# TECHNICAL BULLETIN # EN - 22

**DATE:** OCTOBER 12, 1999  
**MODEL YEAR:** 2000 AND AFTER  
**ENGINE MODEL:** FE6TA  
**BULLETIN #:** EN - 22  
**FILE IN THE ENGINE SECTION OF THE TECHNICAL BULLETIN BINDER**

## FE6TA IDLER GEAR SHAFT CHANGE

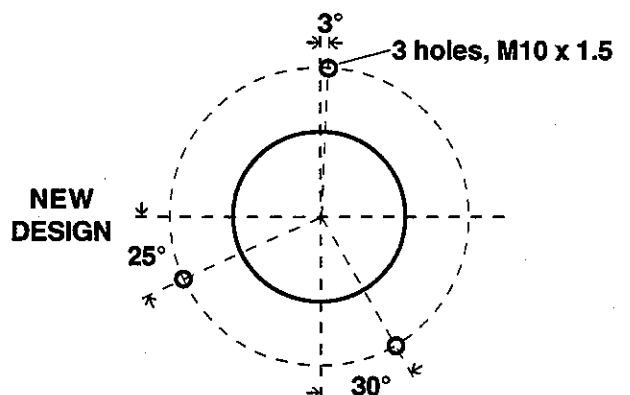
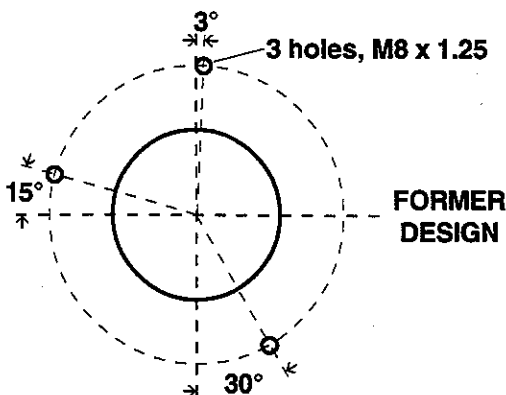
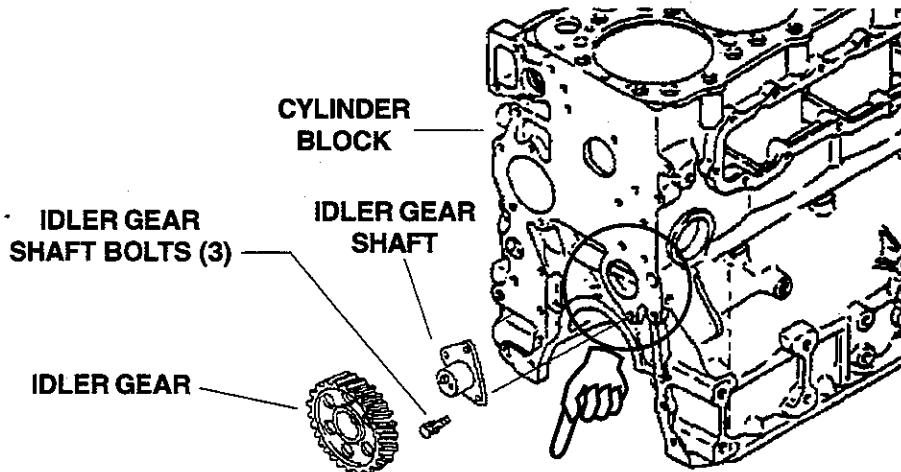
The idler gear shaft in FE6TA engines for medium duty vehicles produced in or after March, 1999 has been changed to further enhance its durability. The bolt diameter and bolthole pattern for mounting the idler gear shaft to the cylinder block have been changed as shown below.
